SUBJECT: FINAL RESPONSE TO TASK INTERFACE AGREEMENT 2015-01,
ASSESSMENT OF THREE MILE ISLAND NUCLEAR STATION'S USE
OF A NON-SEISMIC QUALIFIED CLEANUP PATH FOR THE
BORATED WATER STORAGE TANK

TASK INTERFACE AGREEMENT 2015-01

ASSESSMENT OF THREE MILE ISLAND NUCLEAR STATION'S USE OF A NON-SEISMIC

QUALIFIED CLEANUP PATH FOR THE BORATED WATER STORAGE TANK

Figure 1: Sketch of BWST Cleanup Flow-Path

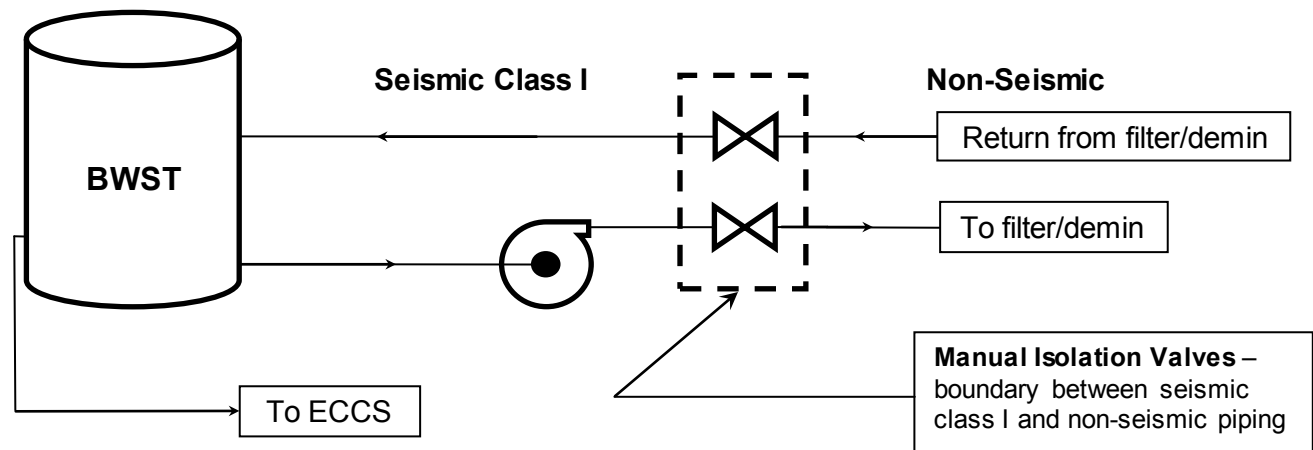
The BWST water is expected to be clean, clear, and without debris to support its use in the reactor systems and refueling operations. To maintain these expectations, the water is periodically processed through a cleanup flow-path that includes (1) pre-coat filters and cation demineralizers in the liquid waste disposal system and (2) portions of the spent fuel pool system. The sections of the supply and return piping in the cleanup flow-path connected to the BWST are qualified as seismic Class 1, but the supply and return flow-paths transition from seismic Class 1 to non-seismic (e.g., Class II) piping at two manual isolation valves located in the basement of the auxiliary building (See Figure 1 below).

TIA assessment, the physical concern underlying the licensing basis discussion is that an earthquake could rupture the non-seismic piping when it is in communication with the BWST (i.e., boundary isolation valves are open), rendering the tank inoperable from the TS standpoint due to a reduction in the tank's inventory. This would prevent the BWST from supplying a sufficient amount of borated water to the ECCS injection pumps, which would preclude the system from being credited assuming there was a requirement for it to withstand a safe-shutdown earthquake (SSE) while maintaining operability in accordance with TS.

Based on a review of TMI's licensing basis (i.e., the draft GDC and design bases in the UFSAR), the NRR staff has concluded that the BWST cannot be credited to perform its intended safety function when it is connected to the non-seismically qualified piping for cleanup. This configuration is unanalyzed and renders the BWST inoperable according to TS. Also, manual actions are not approved as a justification for compliance with Criterion 2 of the AEC draft GDC. Finally, since this viewpoint represents a consistent position from original licensing to the present, the NRC staff position does not constitute backfitting.
